## **Comments Concerning the Union Station Supplemental Draft Environmental Impact Statement**

July 6, 2023

The Committee of 100 on the Federal City provides these comments concerning the May 12, 2023, Supplemental Draft Environmental Impact Statement (SDEIS) that supplements the June 2020 Draft Environmental Impact Statement for the Washington Union Station Expansion Project. Washington Union Station is a historic national treasure, a potentially powerful economic driver for the city, a critical piece of the nation’s transportation infrastructure, and an indispensable asset to help our region solve our nation’s transportation challenges of the 21<sup>st</sup> century. These comments, together with the comments of others reveal critical issues that must be addressed to provide a competent, safe, environmentally responsible, and practicable expansion of Union Station that will better serve rail needs beyond 2040. The Committee of 100 has grave concerns about many key aspects of the proposal including (but not limited to) treatment of passenger and commuter rail operations, faulty analysis of environmental emissions and the impacts of those emissions on adjacent neighborhoods, deci

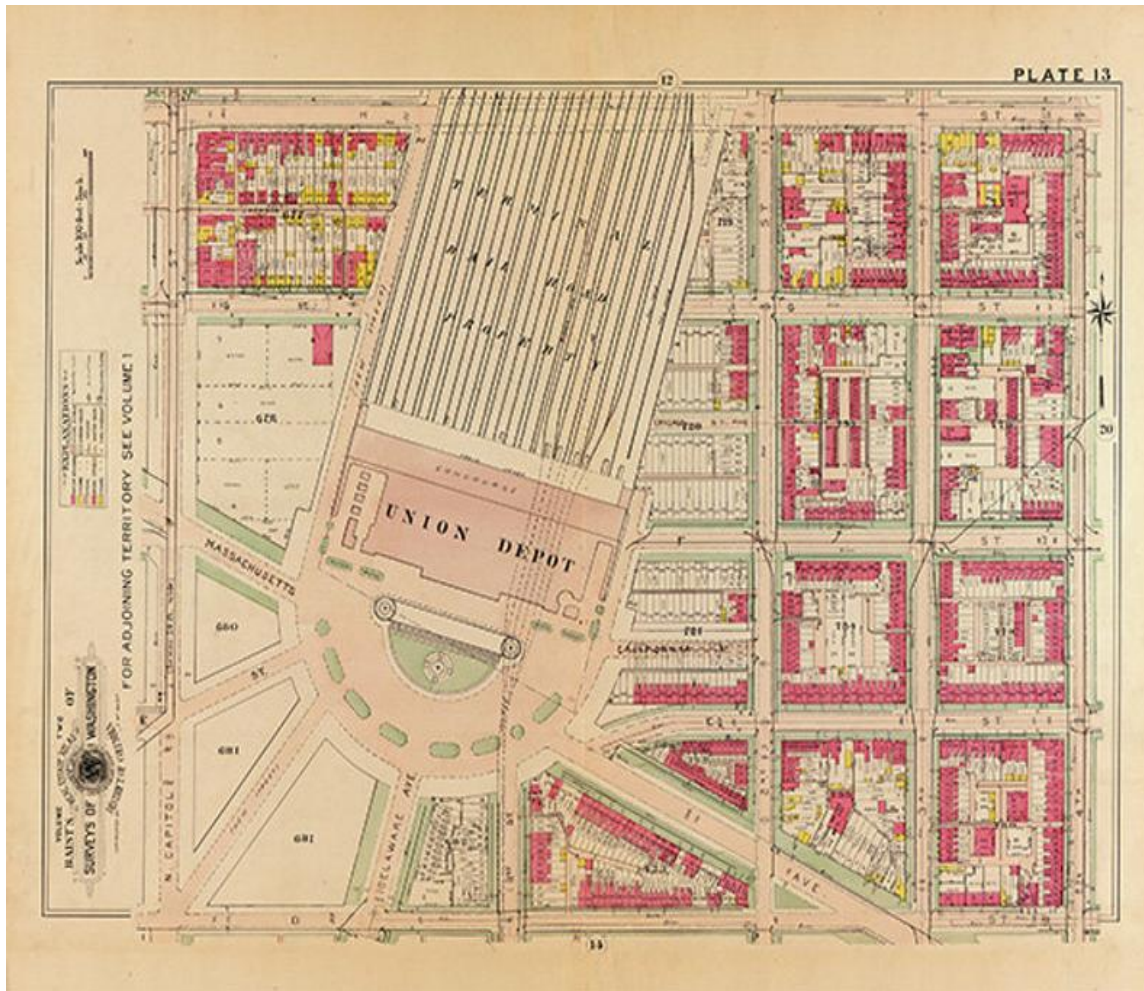
Union Station originally had a total of 33 revenue tracks:<sup>10</sup>

- 24 stub-end tracks ran north of Union Station on the upper level
- 9 run-through tracks on the lower level.
- 2 non-revenue tracks that terminate on the lower level that are labeled “mail tracks.”

The DEIS' Preferred Alternative would provide only 19 revenue tracks:

The reduced number of tracks is, in large measure, determined by the much wider platforms that are proposed. All of the current platforms are less than 20-feet wide, and many are obstructed by columns supporting the parking garage or the H Street Bridge. Widening the platforms to accommodate capacity growth and safety standards requires realigning and re-spacing the station tracks that reduces the number of revenue tracks<sup>12</sup> A key unaddressed issue in the plans, but must the platforms be as wide as 30 to 35 feet?<sup>13</sup>

Figure 5-3. Preferred Alternative Operational Noise Levels

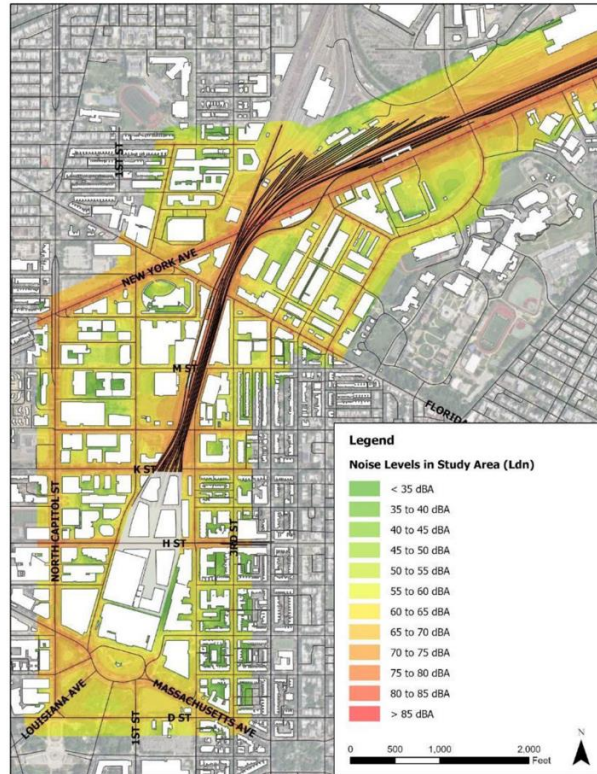
The 2020 DEIS acknowledges expansion of the Ivy City Rail Yard (Exhibit B, page 10), and the SDEIS includes noise and vibration emanating from the Ivy City Rail Yard (Chapter 5, page 5-70).

However, air pollution from diesel switchers is **not** included. Logically, this air pollution must be included. Noise and vibration end when the source is switched off, but air pollution persists and spreads. In its rules on power plant emissions EPA recognizes that polluted air moves from its source and uses a 3-mile radius to measure effects.<sup>32</sup> See EPA, Clean Air Power Programs, *Power Plants and Neighboring Communities*, [Power Plants and Neighboring Communities | US EPA](#). Certainly, the polluted air emanating from the nearby Ivy City Rail Yard must be included in an environmental impact analysis. DC’s Department of Environment and Energy (DOEE) has quantified the diesel emissions that result from switching and moving trail equipment to, from, and within the Ivy City Rail Yard,<sup>33</sup> the total emissions from switching is 10,024.7 tons per year.

**Figure 1. Parking and Retail Revenues for Fiscal Years 2000 Through 2012, in thousands of dollars**

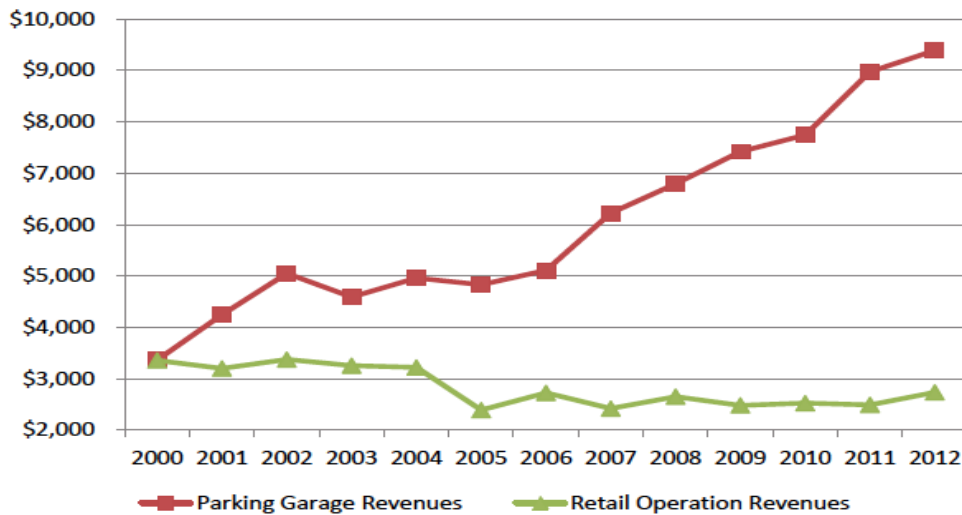
*While revenues from garage operations have increased, revenues from commercial operations have decreased over the past few years. Specifically, between fiscal years 2000 and 2012, parking revenues increased from \$3.4 million to \$9.4 million, while commercial operations revenues decreased from \$3.4 million to \$2.7 million (see Figure 1).*

The C100 supports the need for USRC to have a reliable source of income for its operations, maintenance and historic preservation activities. In the near term, no parking revenue will be available once the extant parking garage is demolished and for several years thereafter during the 14-year period of track realignment and deck construction.

A plan is needed for how to provide an alternative to parking revenue for USRC to continue to operate and maintain Union Station during the 14-year period the expansion is underway. Since the USRC is designated the Project Manager for the 14-year expansion – will the payment to USRC for serving as Project Manager also include a payment for USRC’s management and operation of Union Station?
